DEPARTMENT OF NATURAL RESOURCES  
DIVISION OF OIL, GAS AND MINING

RE: SRS/NOV 89-26-24-1

SUBJECT: EMULSION SPILL PREVENTION

## REDESIGN CALC. FOR MAIN SHAFT EMULSION LINE

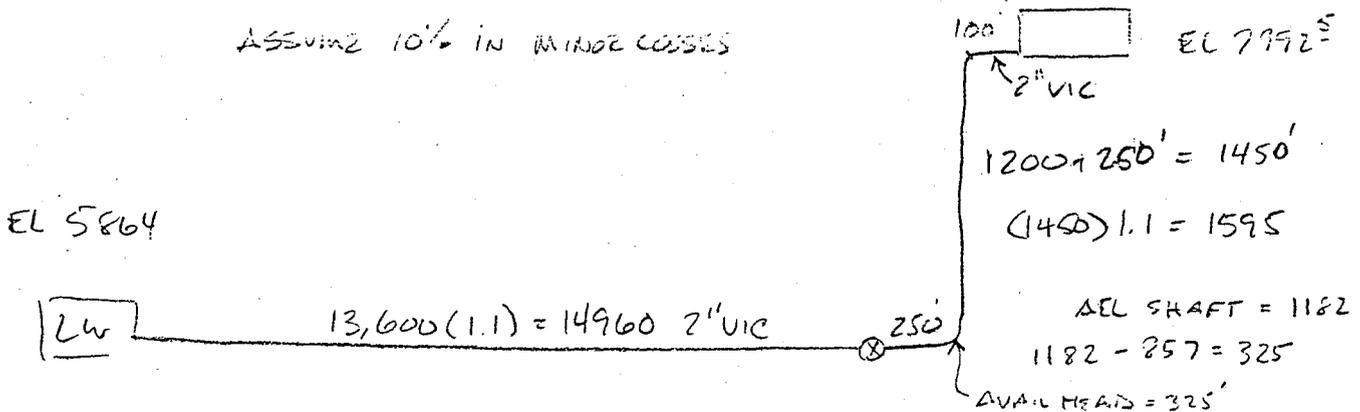
PARAMETERS: 50 gpm REQUIRED FLOWRATE

USE 1 1/4" PIPE IF POSSIBLE

2" VICADLIC PIPE IN MINE FROM SHAFT

BOTTOM TO LONGWALL FACE. DESIGN FOR

WORST CASE - LONGEST PIPE TO 23 LW FACE

ALL THE WAY RETREATED.

ASSUME 10% IN MINE LOSSES

SCH 80 TOTAL 1 1/4" PIPE 1595 EQ LENGTH @ 50 gpm  $H_f = (53.7/100) 1595 = 957$

SCH 40 TOTAL 2" VIC PIPE 14960 EQ LENGTH @ 50 gpm  $H_f = (4.66/100) 14960 = 697$

$$\text{TOTAL } H_f = 1554$$

$$\Delta EL = 7992' - 5864' = 2129 \text{ ft.}$$

$$\text{AVAILABLE HEAD @ LWFACE} = 2129 - 1554 = \underline{575 \text{ ft.}}$$
